MEMORANDUM

To: The Design Advisory Board
From: Mary O'Neil, AICP, Senior Planner *M. O'Neil*
RE: ZP 14-0061CA; 87 King Street
Date: August 13, 2013

Request: Rebuilding and renovation of the King Street Center on the existing footprint.

Landscape Plan

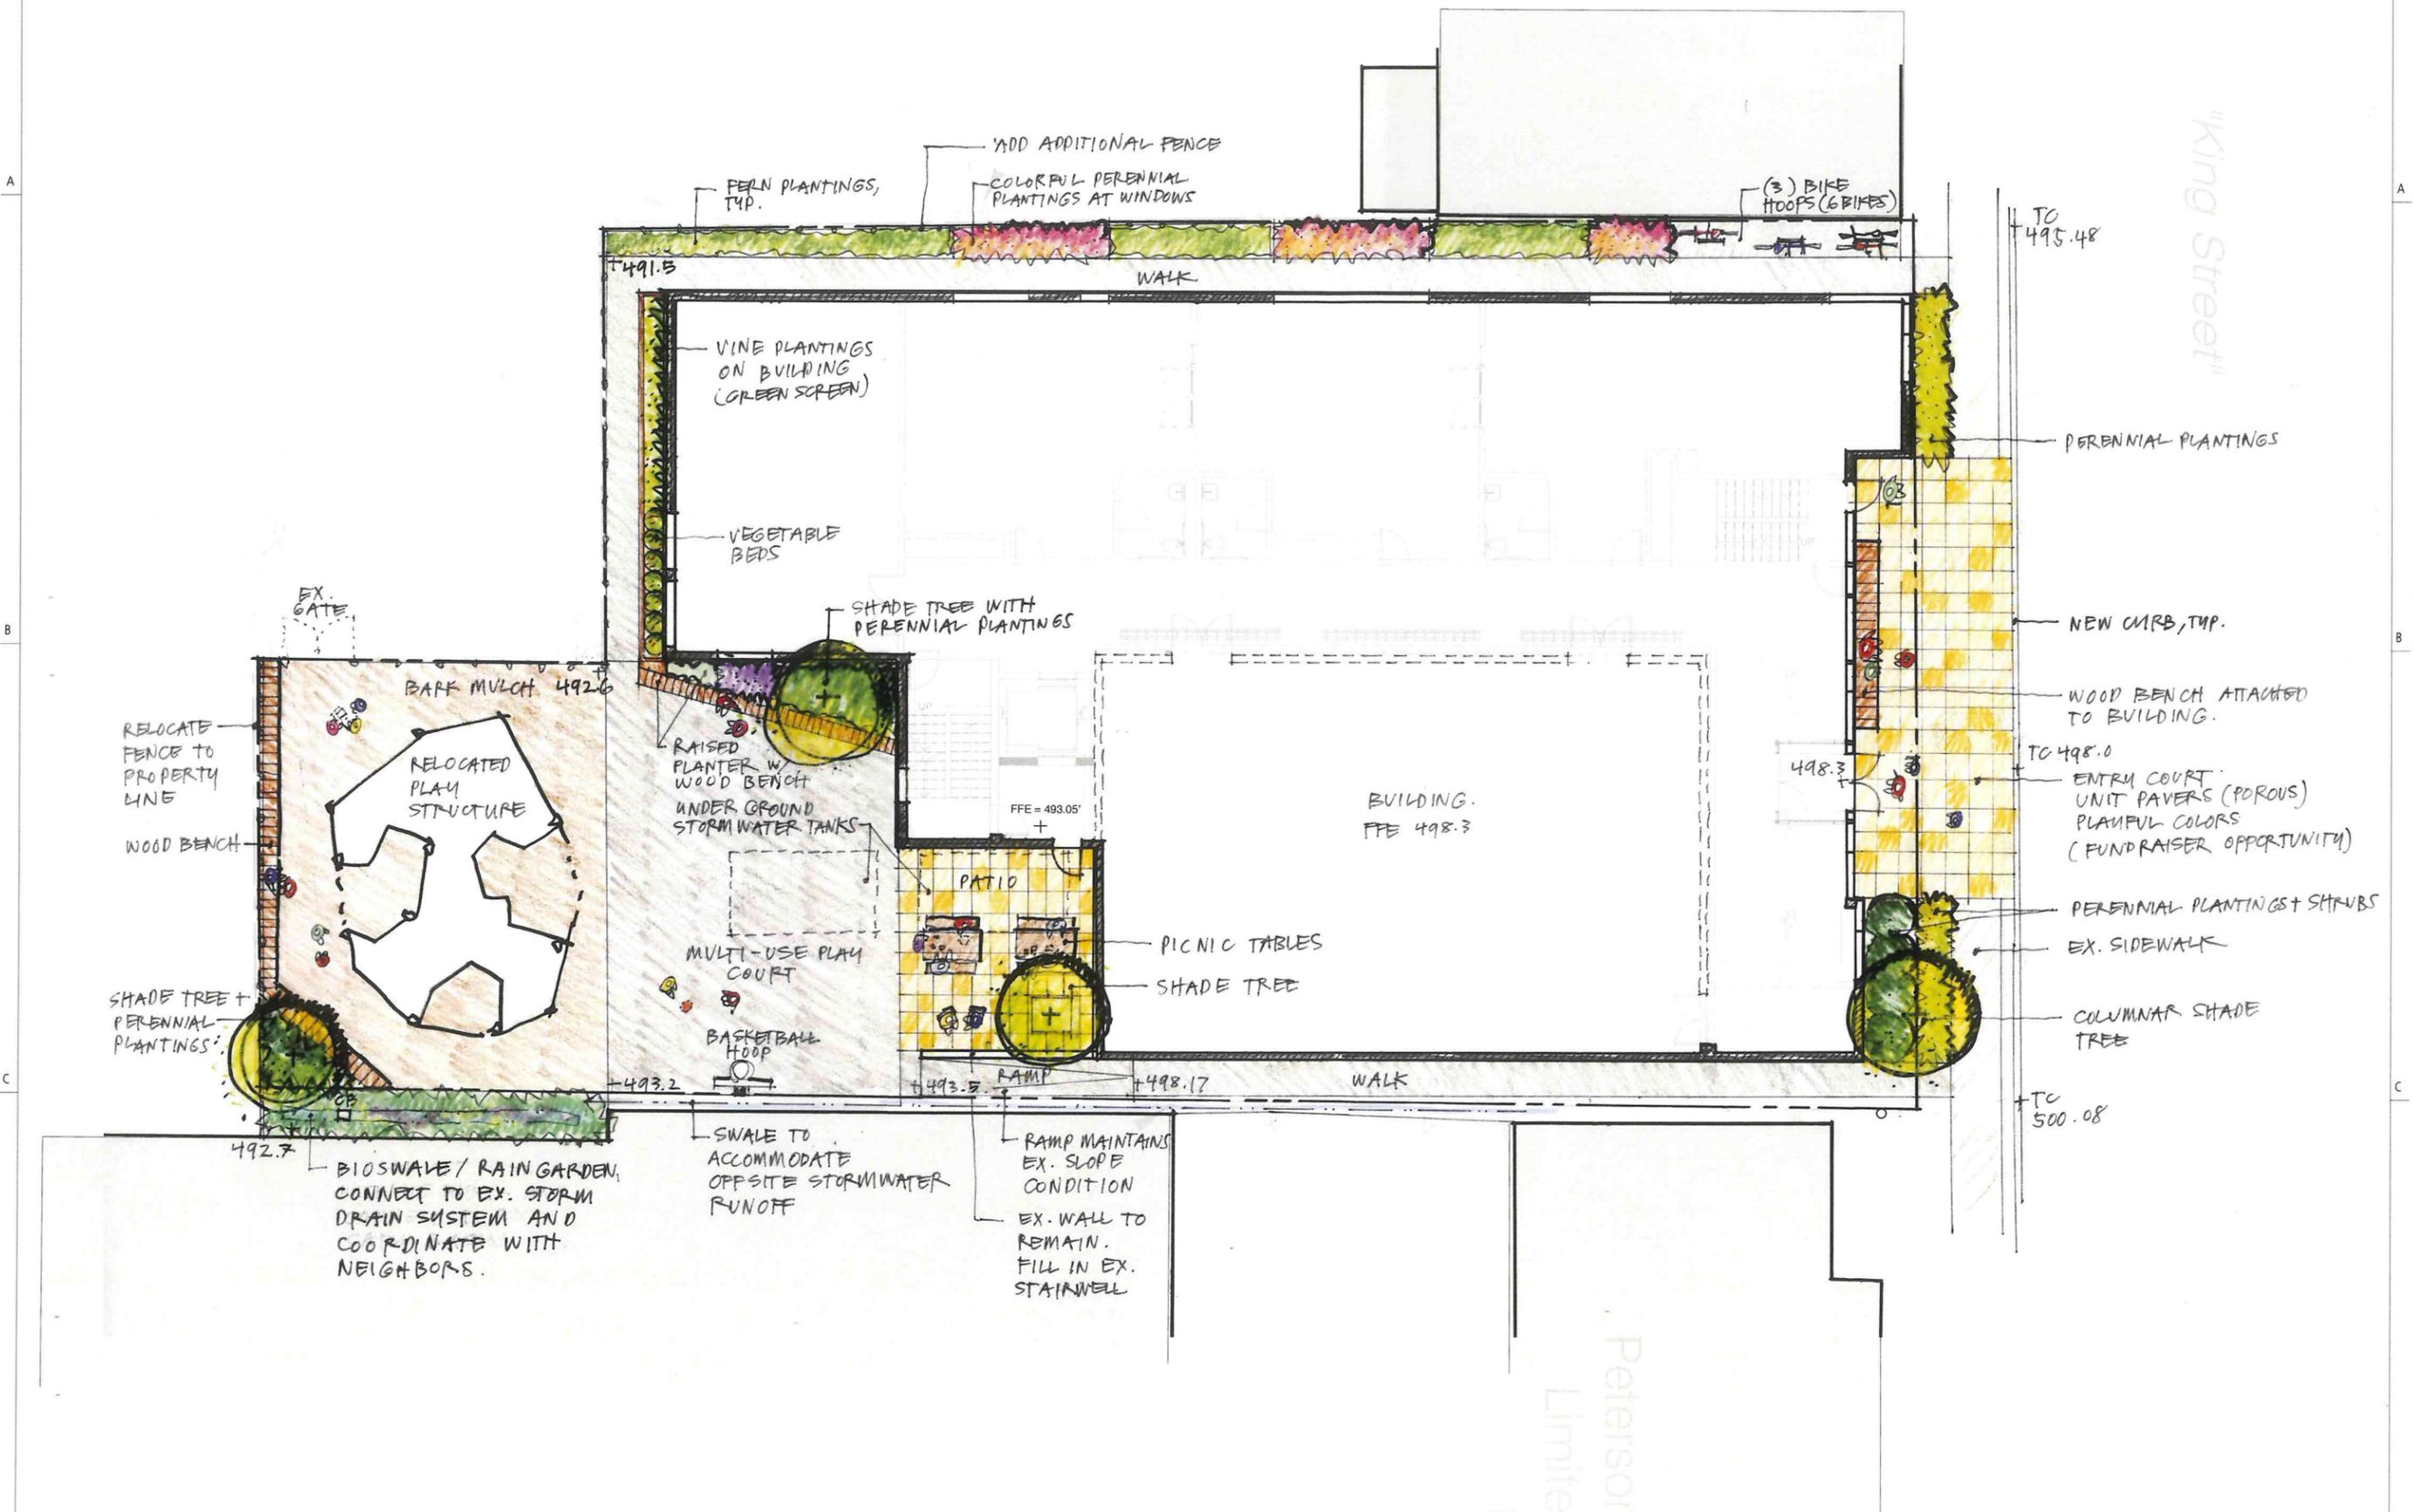
The project proposes significant perennial plantings along the front (north) elevation and parallel to the west walkway. Vines are proposed at the southerly building façade, with a raised bed landscaped area adjacent to the multi-use playcourt. A bioswale / raingarden are proposed for attenuate stormwater at the southeasterly corner of the lot. New shade trees are proposed in four different locations on the very constrained site.

The landscaping plan (L1.0) also highlights the fact that the proposed entry court crosses the property boundary into the public right-of-way. While functionally it completes the “public entry court” function, it is proposed on public lands. The City Engineer provides the following process for review of projects proposing the use of the right-of-way:

The applicants shall consult with the city arborist as to appropriate tree species choice for the project.

Floor Plan - Level
(Ground)

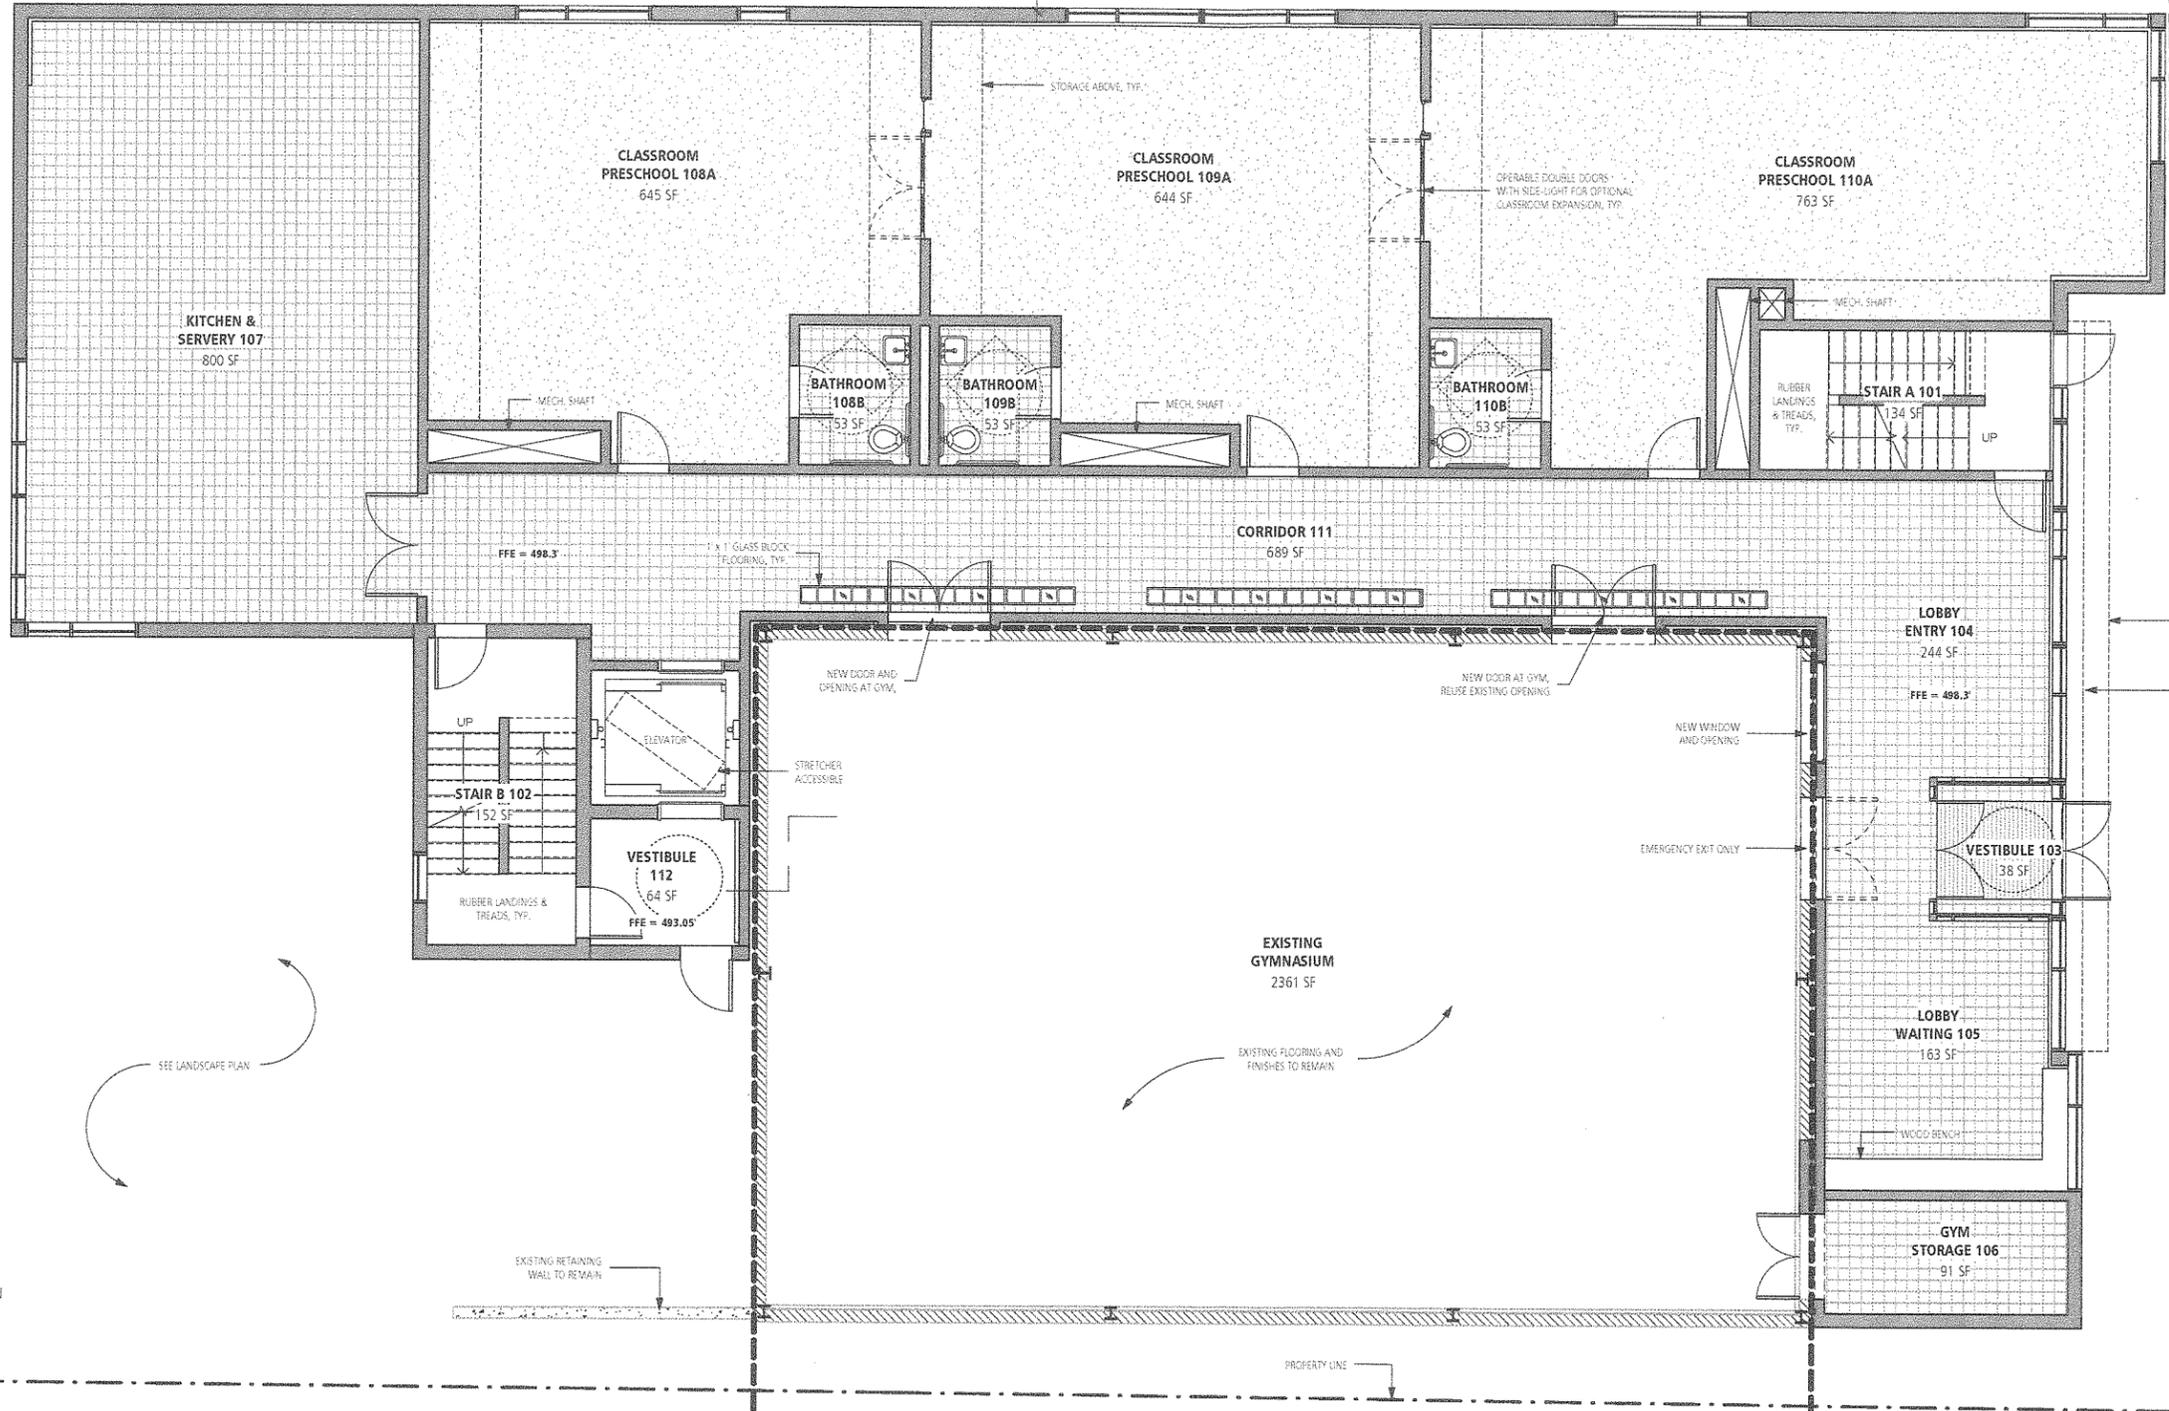
Fenestration pattern occurs in sporadic horizontal bands, reflecting internal activity. The arrangement on the primary (north) façade directs the eye upward toward the uppermost floor. The entry canopy will be required to be mounted at a height directed by the ordinance. It does not encroach into the public ROW per submitted drawing A102.
